# UNITED STATES PATENT AND TRADEMARK OFFICE

APPLICATION NO.	FILING DATE	FIRST NAMED INVENTOR	ATTORNEY DOCKET NO.	CONFIRMATION NO.
10/813,928	03/31/2004	Admir James Mesalic	MES1.002	5800
39863	7590	05/18/2006	EXAMINER	
SONNABENDLAW 600 PROSPECT AVE BROOKLYN, NY 11215			EDEL, JOSEPH F	
			ART UNIT	PAPER NUMBER
			3636	
DATE MAILED: 05/18/2006

<b>Office Action Summary</b>	Application No. 10/813,928	Applicant(s) MESALIC ET AL.	
	Examiner Joseph F. Edell	Art Unit 3636

Diagram A - Annotated Figure 1 of Hannigan

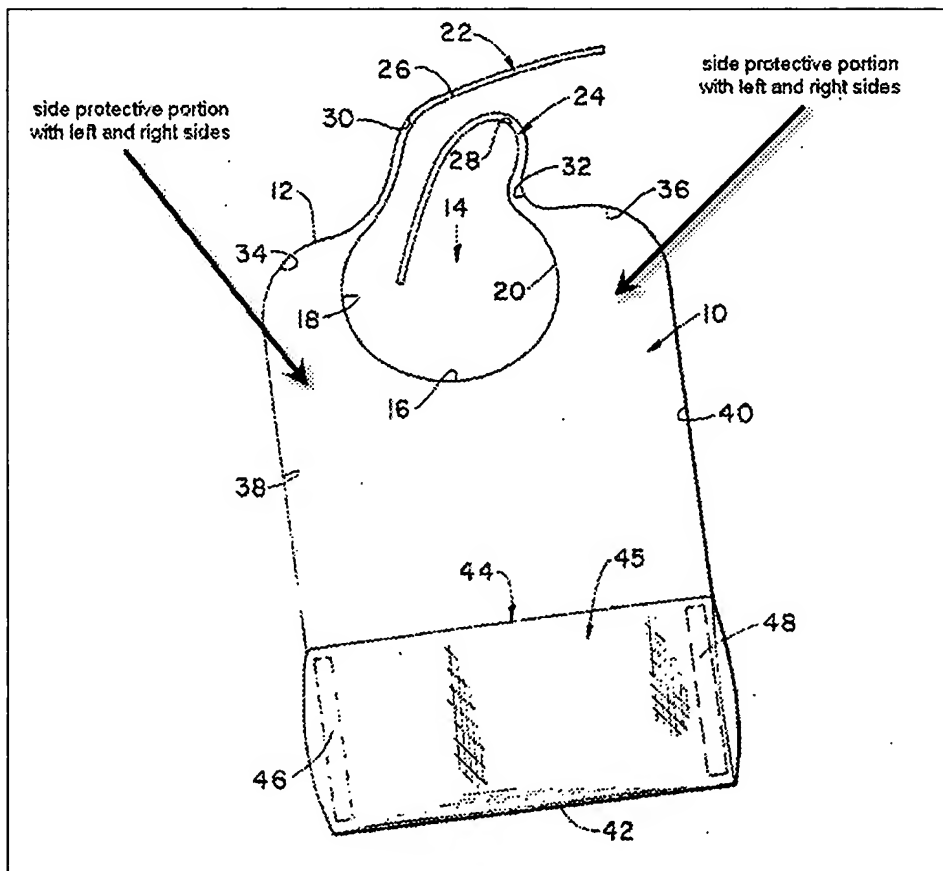
Hannigan discloses a protective covering that includes all the limitations recited in claims 6-12, 35, 39, and 41. Hannigan shows a protective covering having a main protective portion/main placemat area (See Fig. 2), a front protective portion/at least one side flap (see Fig. 1) attached to the main protective portion, two side protective portions/side flaps (see Diagram A below) with left and right sides and orthogonal to the front protective portion, and a coupling element 22,24 of the side protective portions that is ribbon ties, and a bottom side of the main protective portion including skid resistant portions 46,48 wherein the front protective portion is capable of attaching to a front arm

portion of a child's chair and to extend from a table top to the child's chair, the main protective portion including a pocket 44 (Fig. 1) formed therein.

is capable of connecting the sides of the side protective portion by wrapping around the side protective portion, and, therefore, claim 8 is anticipated by Hannigan.

With respect to claim 10, the drawings remain objected to under 37 CFR 1.83(a) because the claimed skid resistant portions are not shown in the drawings. Applicant argues that the tape straps do not meet the limitation of claim 10 because the straps are used to form the pocket 44. However, the pocket is an optional feature of the covering disclosed by Hannigan. Claim 10 recites that the bottom side of the main protective portion includes skid resistant portions. When the tap straps of Hannigan are not being utilized in forming the pocket, the tape straps meet the limitation of the skid resistant portions of claim 10 because the tap straps would resist skidding of the protective covering when laid upon a surface.
